MEMORANDUM

SUBJECT: CDP 2020-0020 AND RECOMMENDATIONS TO AVOID GEOLOGIC HAZARDS

RE: Response to Comments, Planned Residence, 2900 South Highway 1, Elk, Mendocino County, California

AERIAL PHOTOGRAPH / GEOLOGIC MAP

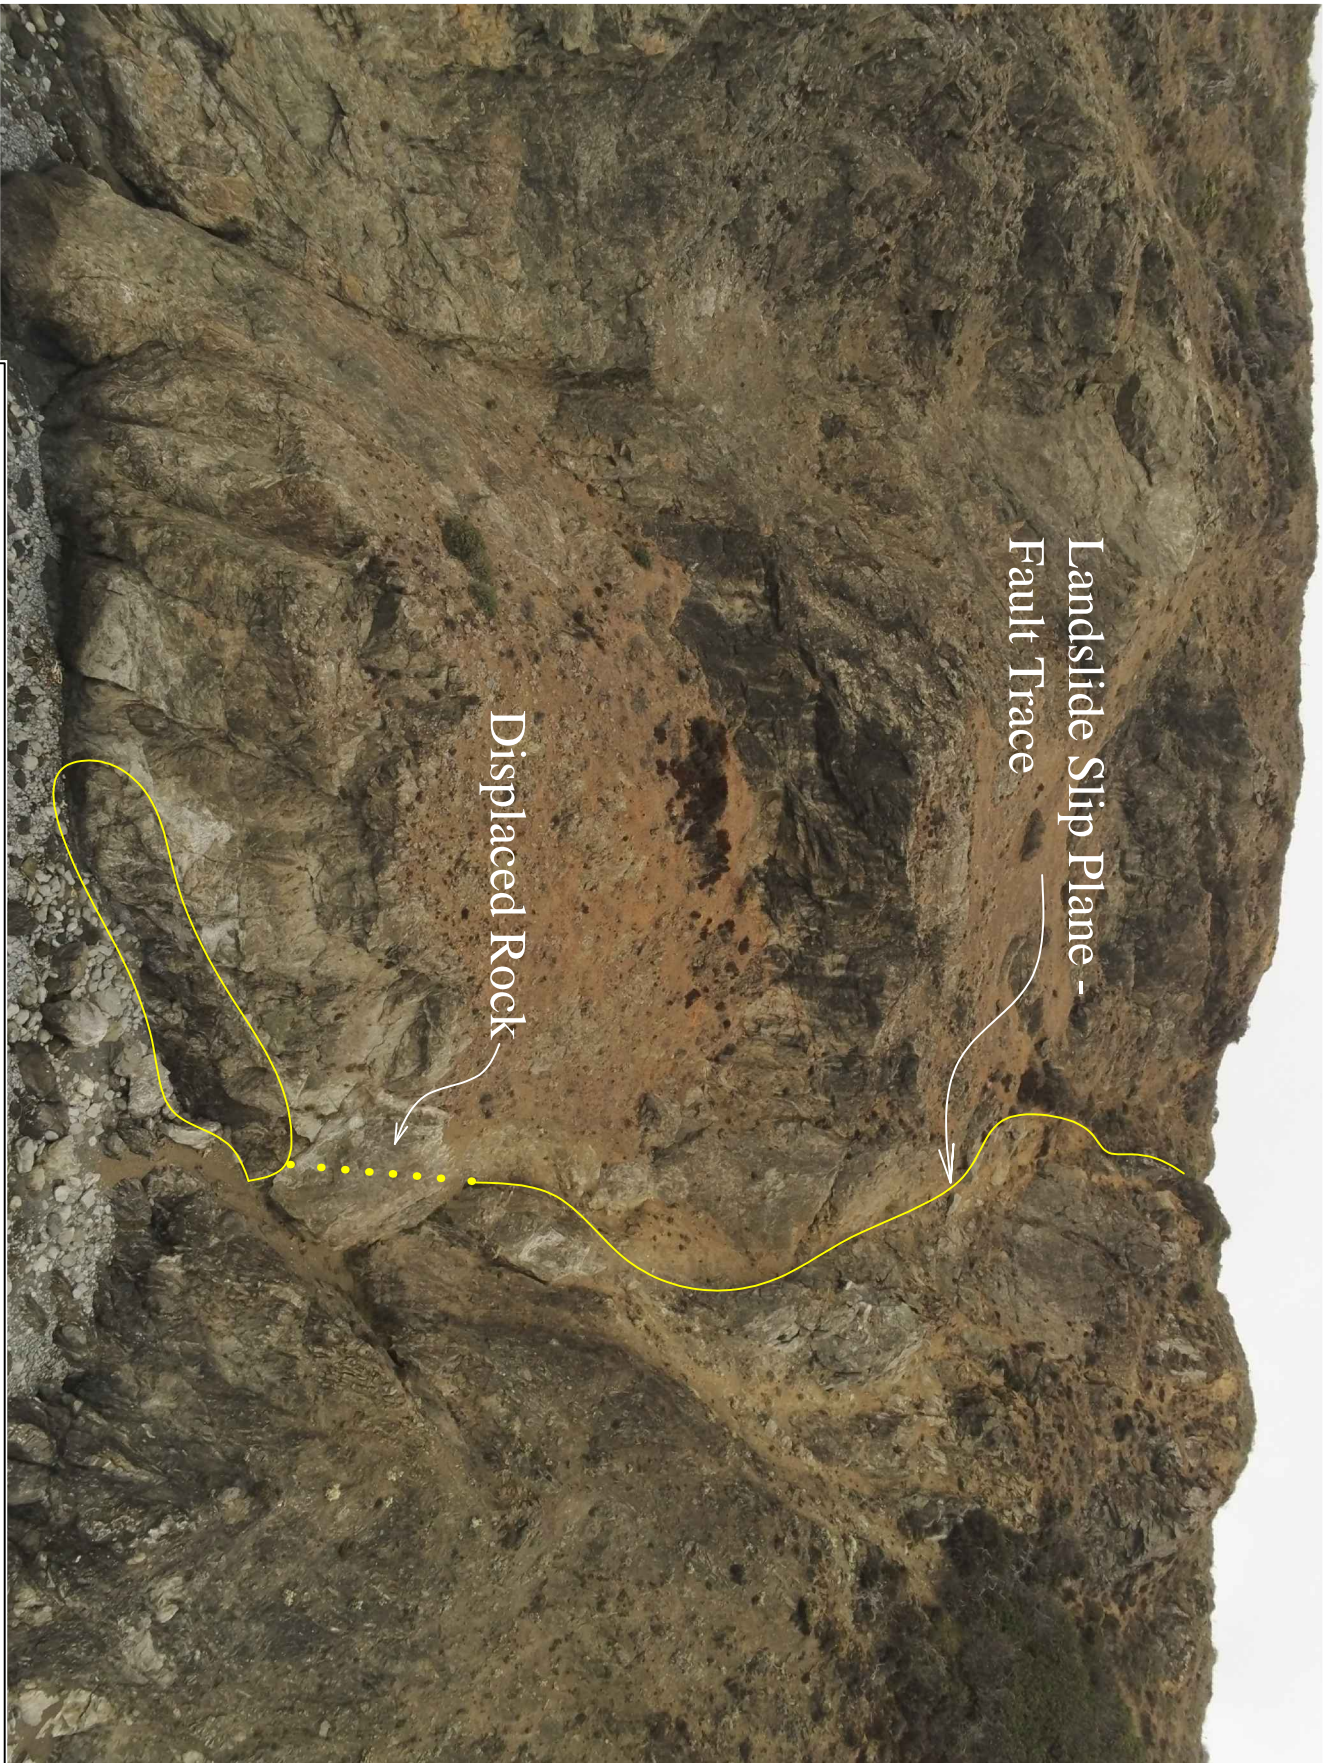
There is an existing, active landslide on the southern portion of the bluff. More information is needed to determine the cause of the landslide and whether geologic structures in the bluff (e.g., faults, fractures, joints, etc.) could promote further bluff instability at the site

The Brunsing reports identify an existing bedrock landslide on the bluff face on the southern portion of the site, affecting the portion of the property adjacent to the proposed guesthouse and barn (represented by cross-section B-B' in the geotech reports). The landslide predates 1972 (the earliest aerial photograph consulted by Brunsing) and also appears to be present in a 1963 photograph that I looked up for the site. Brunsing indicates that this landslide is active, having dropped vertically about 15 feet in historical time. Brunsing also identifies an active zone of slope creep ("incipient landslide") upslope and inland of the main landslide scarp. The landslide is moving slowly at present, and on its own would not pose a threat to new development with a sufficient setback. The existing landslide could be indicative of the potential for future bluff instability farther inland (in the area of proposed development), related to the geologic structure of the bluff, and it's unclear why the geotechnical reports do not address this possibility.

Suggest the County ask applicant to provide additional discussion of the potential for future landsliding at the site. This should include discussion of the factors contributing to the existing landslide (e.g., faulting, fractures or other planes of weakness within the Franciscan bedrock), and whether the intact, unfailed portions of the bluff farther inland possess adverse geologic structures that could promote further slope instability, especially during a strong earthquake.

The existing landslide headscarp appears to be an ancient fault, as shown on the attached Aerial Photo Geologic Map, Plate 1. The landslide slip plane (fault trace) is shown in Drone Photograph A, Plate 2. The slip plane is roughly subvertical instead of an arcuate feature which is more typical of landslide slip planes. The fault is likely providing seepage water to the lower portion of the landslide. Fault planes can be a conduit for fresh (based upon previous fault observations in a marine environment) water coming to the surface from greater depths.

Except for the upper terrace deposits and weathered bedrock, the northeasterly side of the fault is mostly hard bedrock. The current bluff face near the building site is comprised of hard bedrock that was previously the northeasterly side of the fault. The possible, previous extent of the landslide on the southwest side of the fault is shown on Plate 1.

Landslide enlargement into the planned building area is considered unlikely due to the shallow, hard bedrock in that area.
